South Texas Project  
Units 3 and 4  
Docket Nos. 52-012 and 52-013  
Revised Response to Request for Additional Information

**RAI 03.08.04-18, Revision 1, Supplement 1****QUESTION:****Follow-up to Question 03.08.04-2 (RAI 2964)**

### **Description of Changes to the Radwaste Building General Arrangement Drawings**

FIGURE 12.3-67 RADWASTE BUILDING, AREA RADIATION MONITORS AT ELEVATION 12300 MM

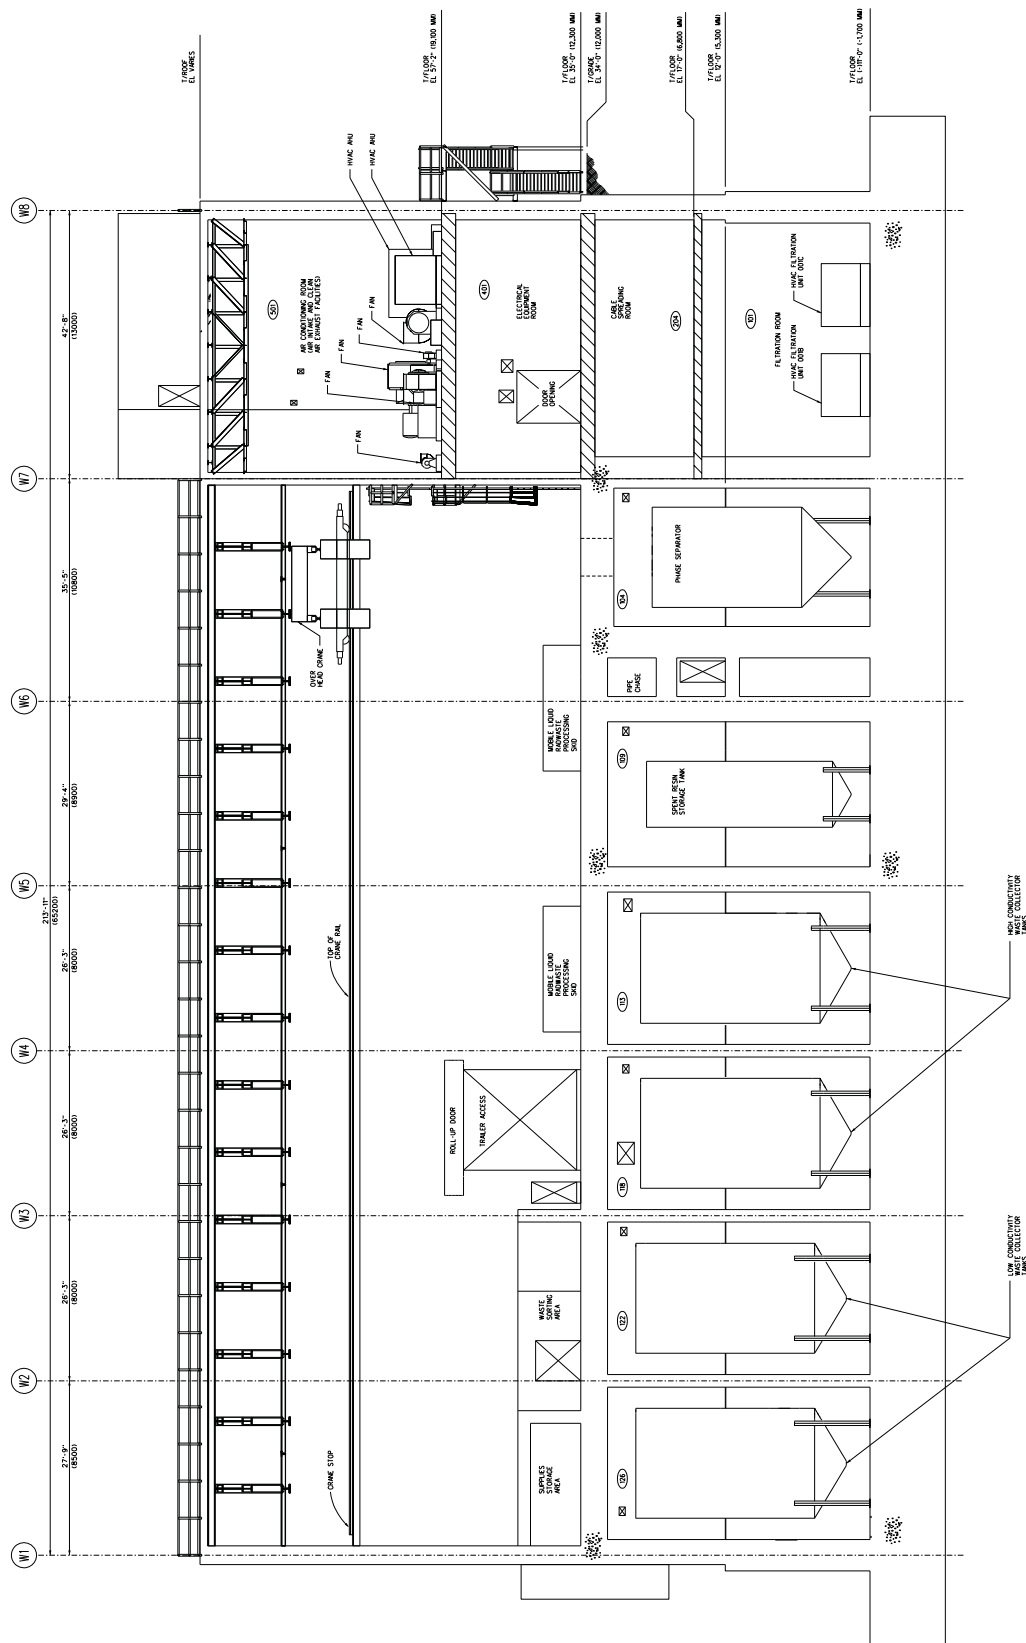
- The Electrical Equipment Room radiation monitor (No. 1) is added to this figure because the room was moved to this elevation. It was previously shown on Figure 12.3-66. This location is comparable to previous location and the function is the same.

This table is revised as a result of the Electrical Equipment Room being moved to elevation 12300 (Figure 12.3-67) from elevation 5300 (Figure 12.3-66). Although some other monitors were moved, they remain on the same set of figures.

FIGURE 9A.4-28 RADWASTE BUILDING, FIRE PROTECTION, SECTIONS A-A AND B-B (SHEET 1)

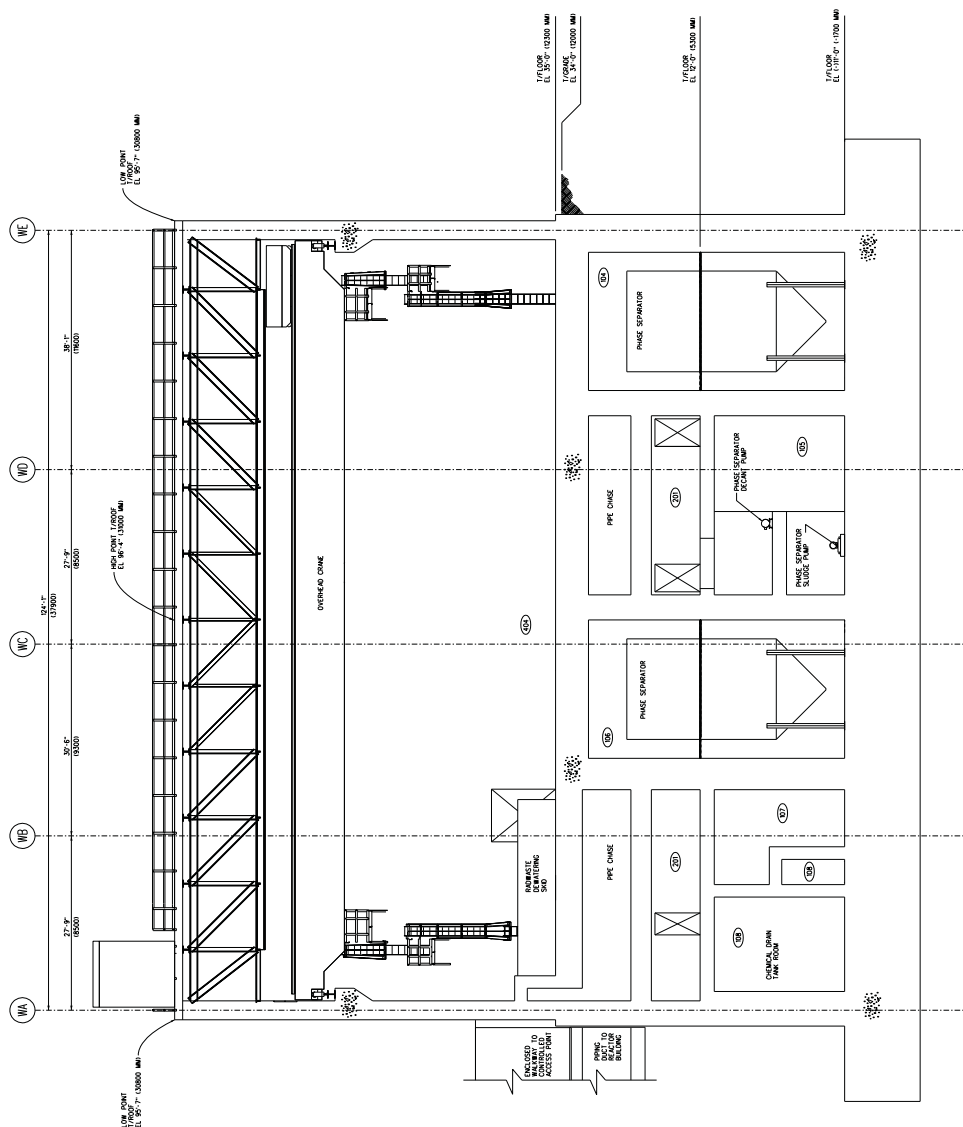
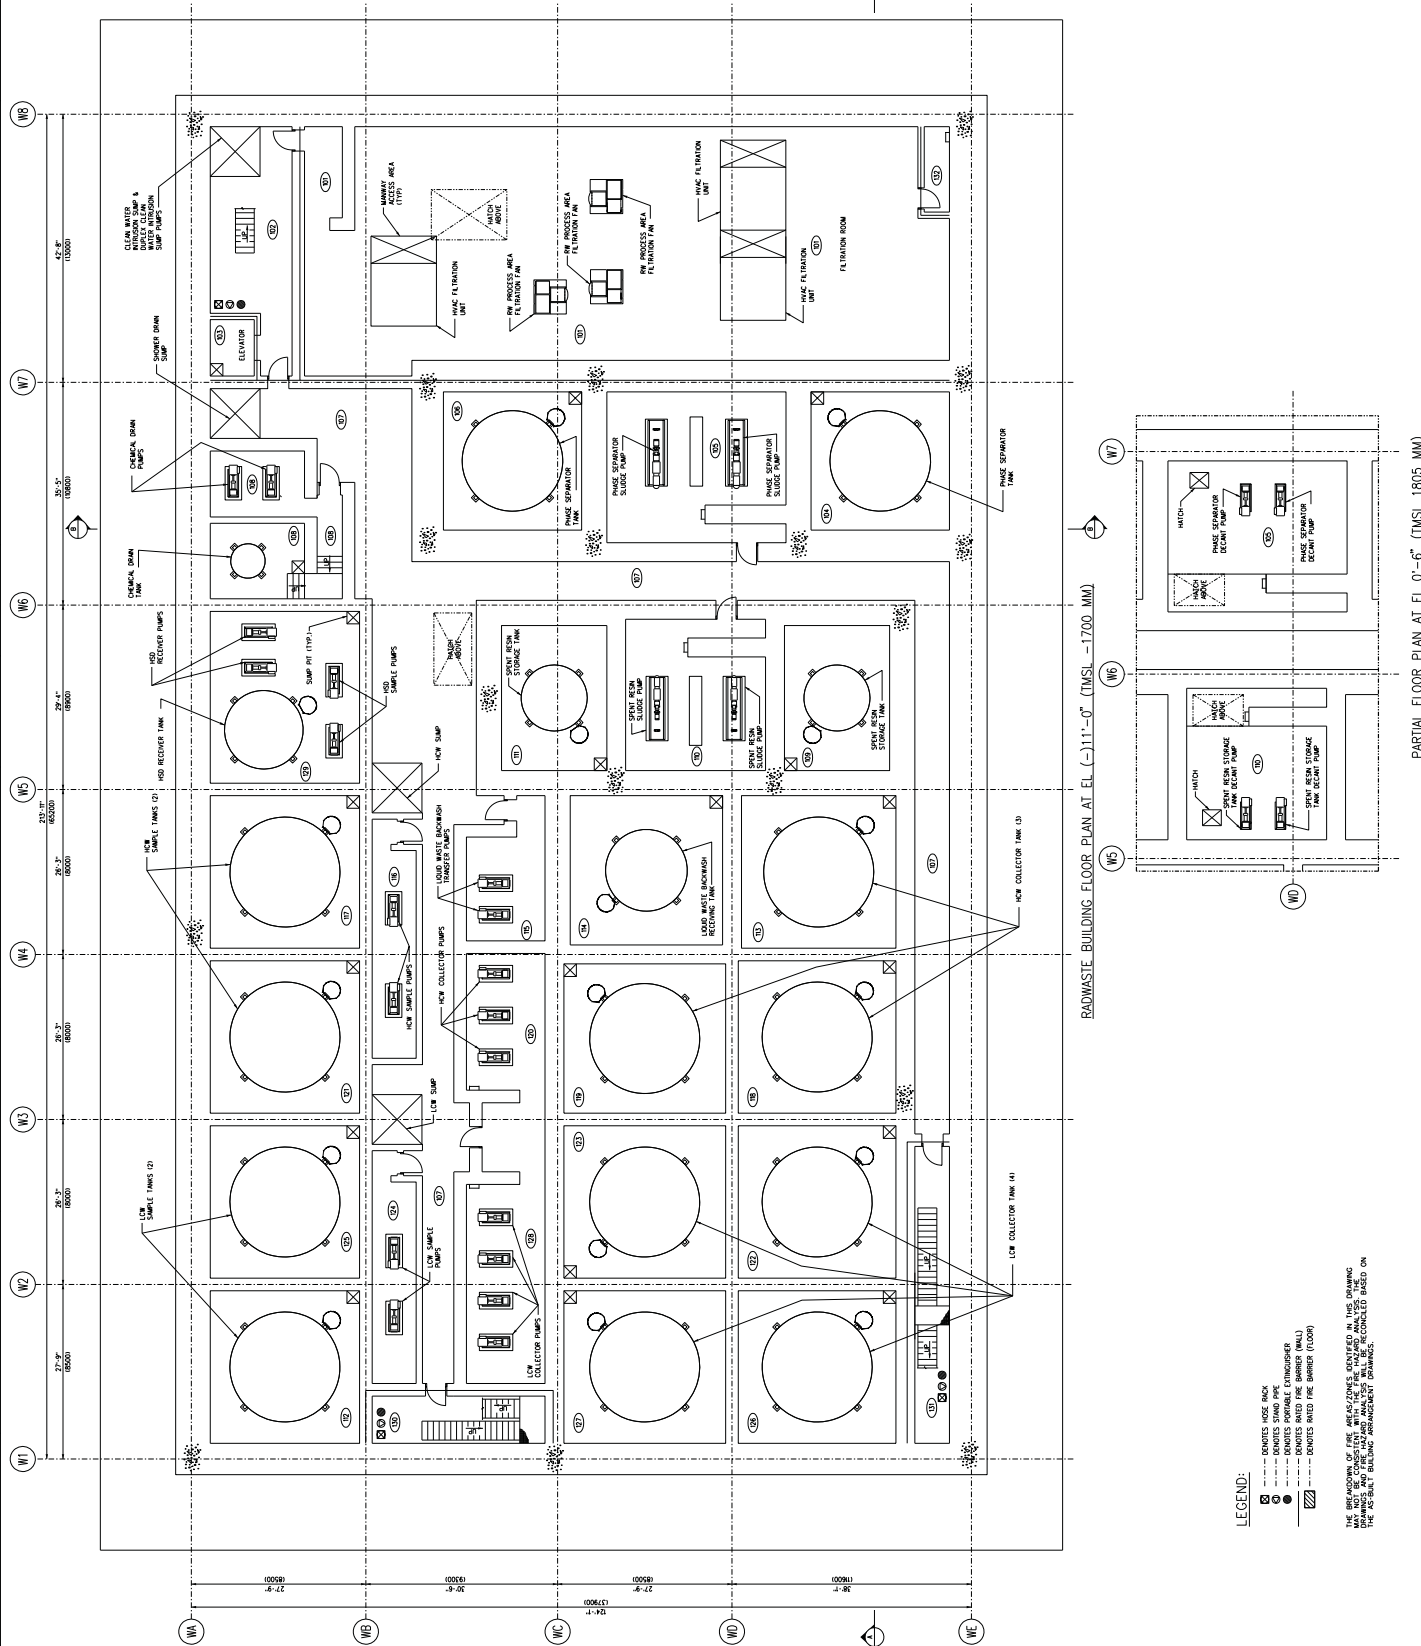
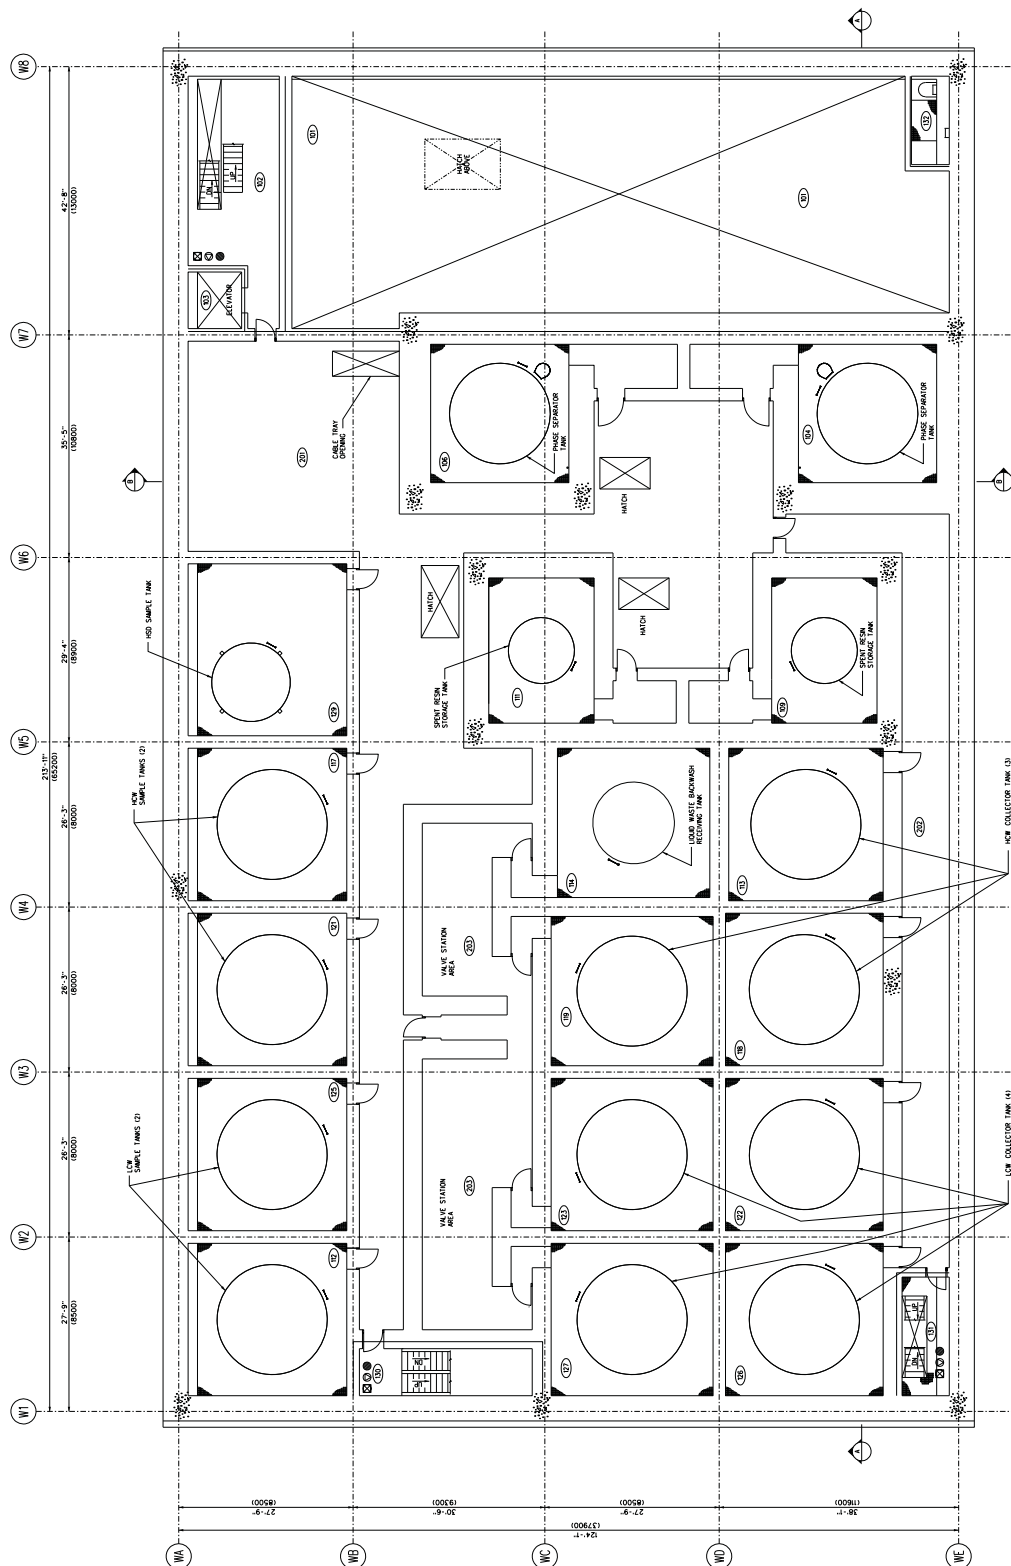
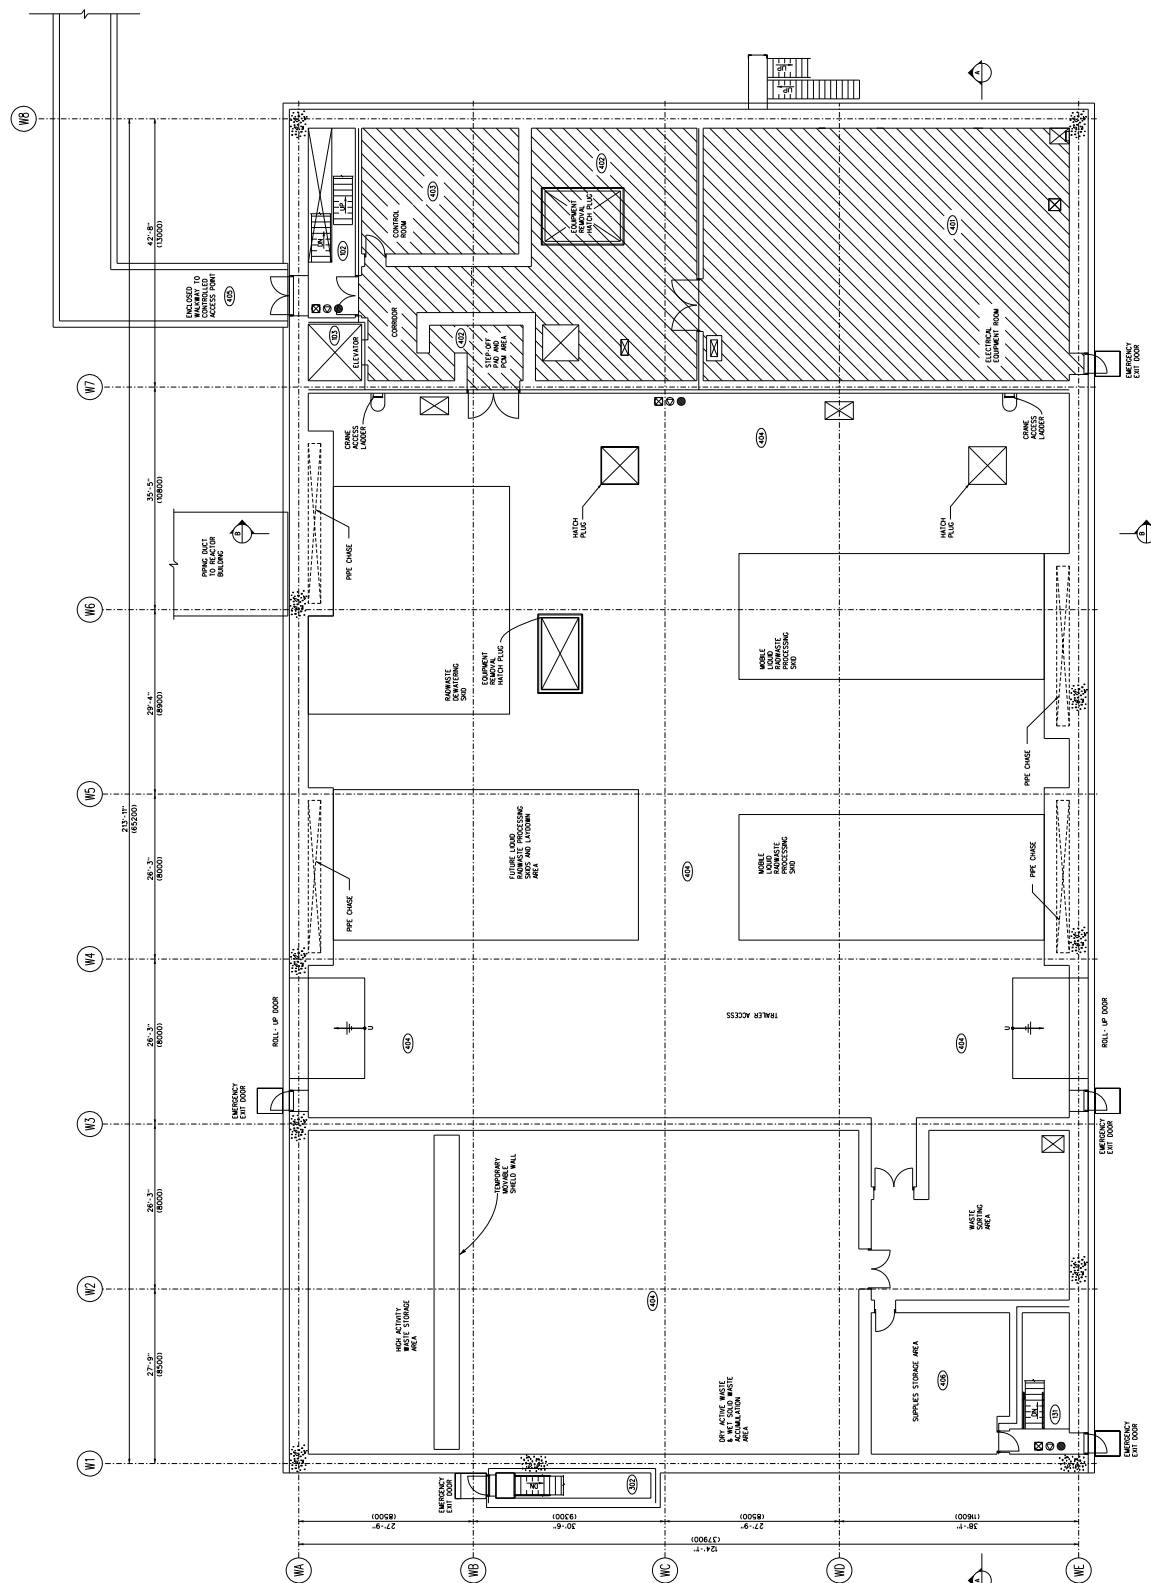
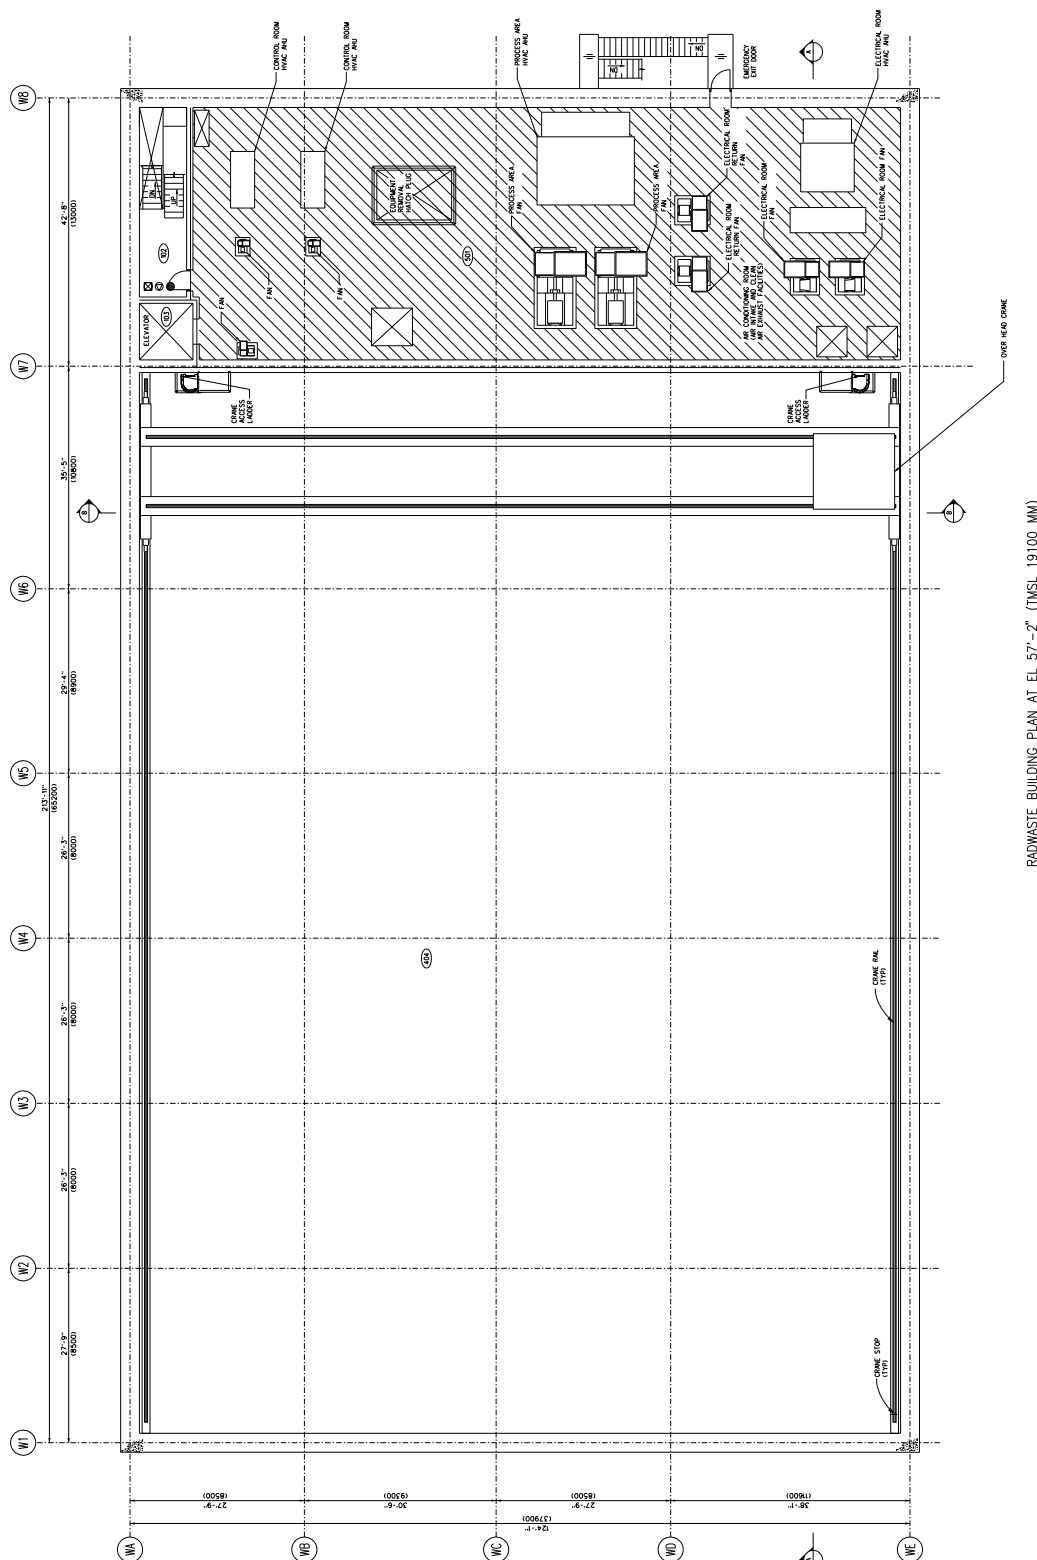
The Fire Protection figures for the RWB are revised to reflect some changed locations of hose racks, stand pipes, extinguishers, and fire barriers (walls and floors). None of these items is deleted or added. The relocation is due to the interior reconfiguration of the RWB discussed in Attachment 1. There are no functional changes to the RWB fire protection provisions.
